BALBOA POOL RENOVATION

Civic Design Review - Phase 3 - Revision

November 16 2014

Phase 2 Conceptual Elevation

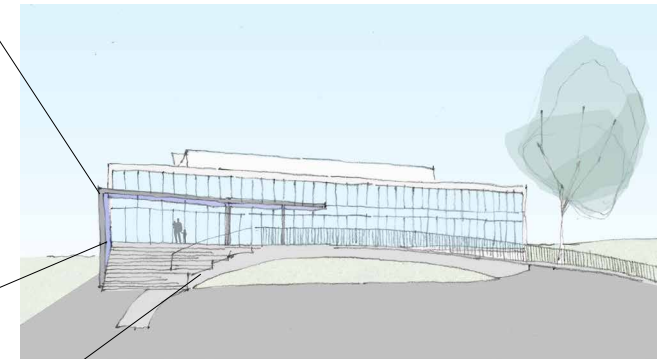
“Motion to approve Phase 2 of the Balboa Pool Renovation project, contingent upon: (1) further developing the articulation of the roof and wall, with informal review before Phase 3 review.”

Informal Review (post Phase 2)
Refined Canopy Roof & Wall

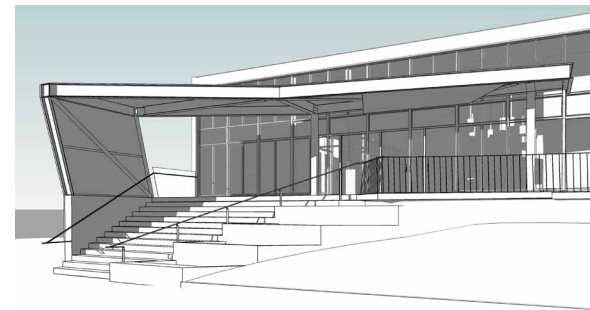
- Refined details for canopy roof and wall

Phase 3 - Review 1
Canopy Construction Details

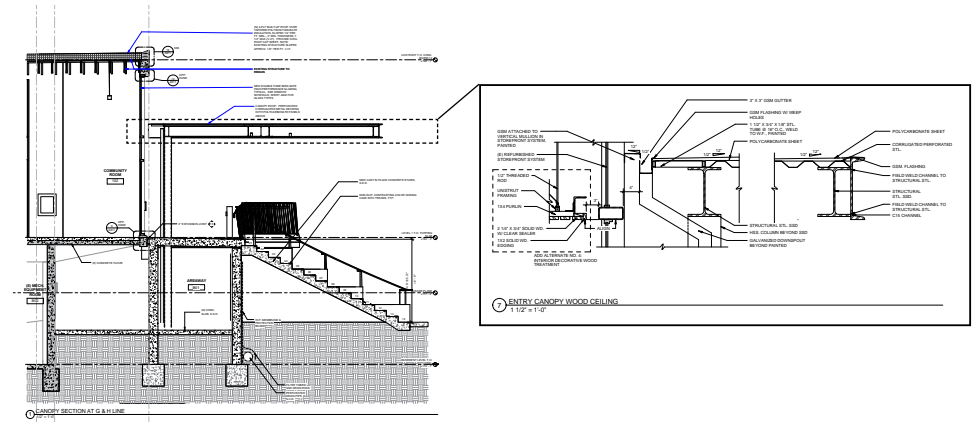
“The Committee discussed the project and requested further clarification on several items and final drawings.”

Phase 3 Revision - Proposed Color

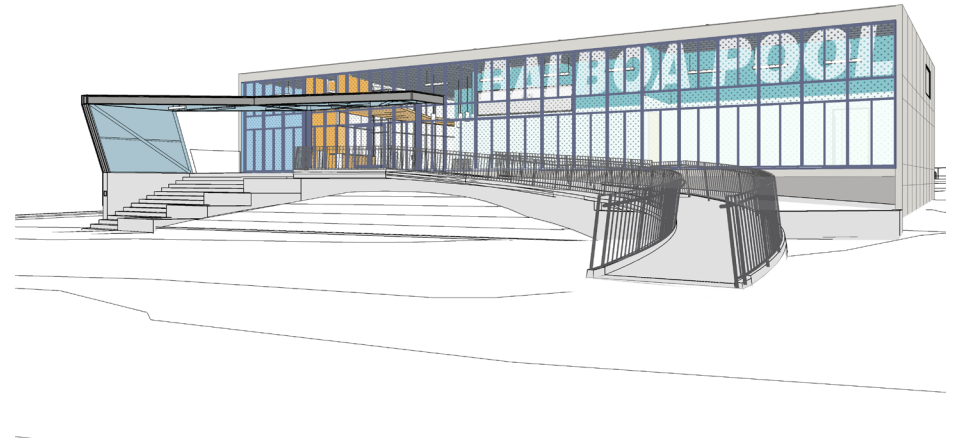
- Refined details for canopy roof and wall
- Color specifications for exterior building materials and relevant interior spaces
- Refined building signage
- Refined Landscape furniture specification and plant selection
